IREDELL COUNTY HEALTH DEPARTMENT

(SEPTIC TANK) IMPROVEMENTS PERMIT AND CERTIFICATE OF COMPLETION
(Ground Absorption Sewage Disposal System – G. S. Chapter 130-Article 13C)

OWNER OR CONTRACTOR Donald Ray Pope DATE 4/27/89 ~~PERMIT NO.~~ Quad # 22C

LOCATION 136 South TR Johnson Dairy Rd. On Left ~ 1/4 mile before the creek. S. R. No. ______

Plot of System

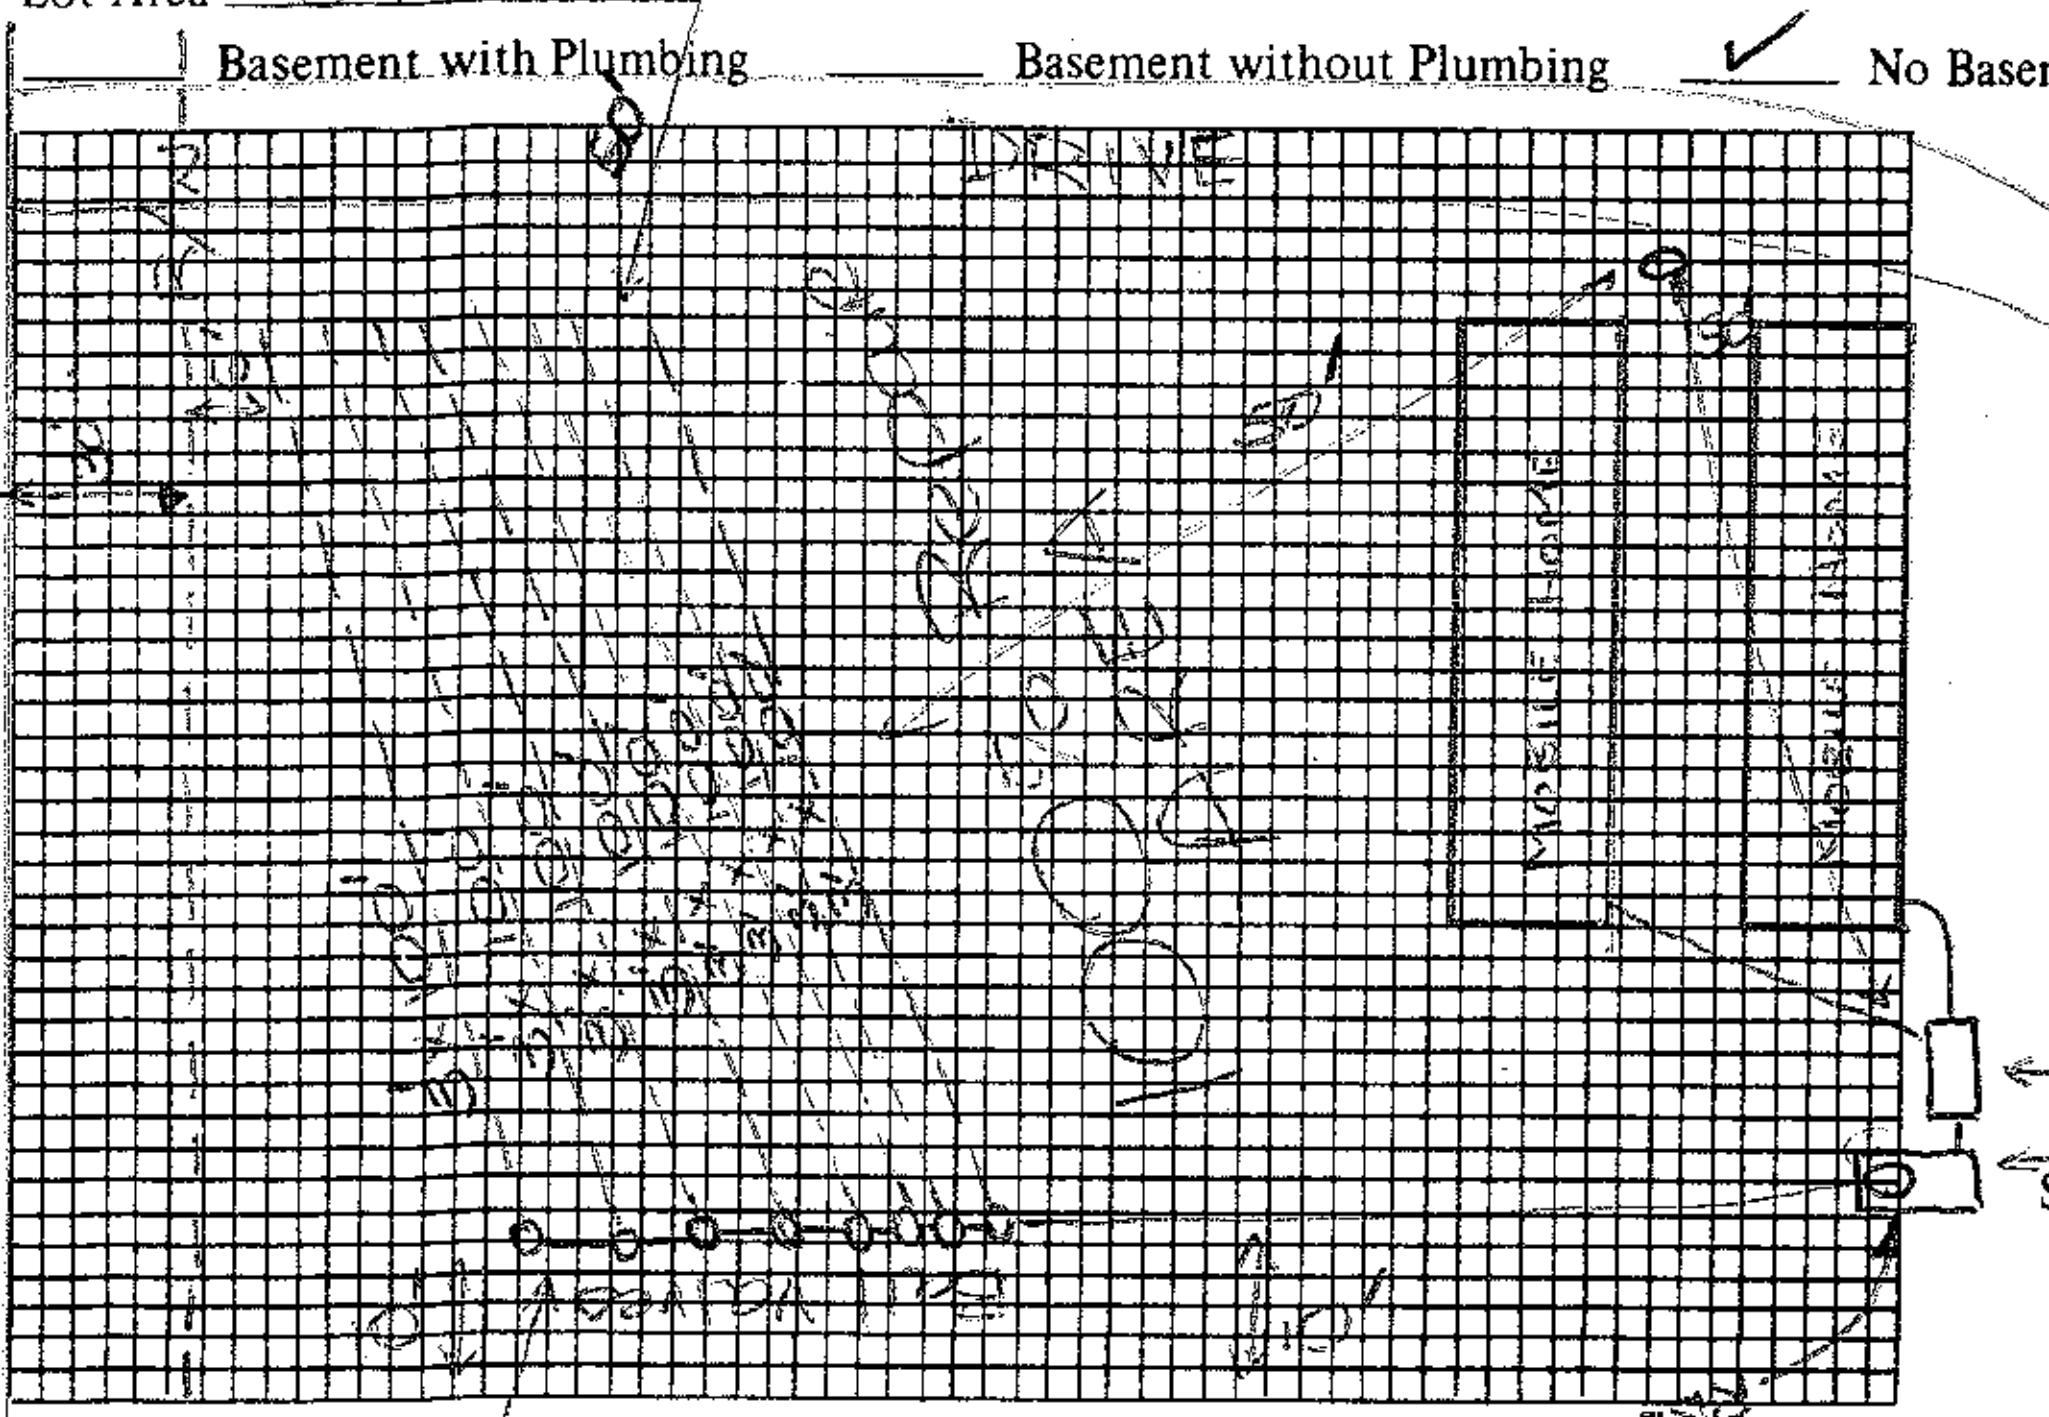
COMMENTS: Install tanks behind 2nd Mobile Home. Run pumpline 10' from property line and install 1st drainline on highest contour in order to install ~100' drainline. Stay 5' from R/W. Drainlines must be shallow (24" MAXIMUM) and

CERTIFICATE OF COMPLETION BY lines must be ON CONTOUR & level. DATE ______

EXISTING SYSTEM CHECKED BY: ~~[illegible]~~ Use 3" pumpline and reduce DATE

Permit is VOID if any unauthorized changes are made in installation of system and/or if any false information is supplied in making Improvements Permit. to 1 1/2" Sch. 40 PVC. w/ 5/32" hole every 5'.

Pumps should deliver 66gal/min with a total head of 25'.
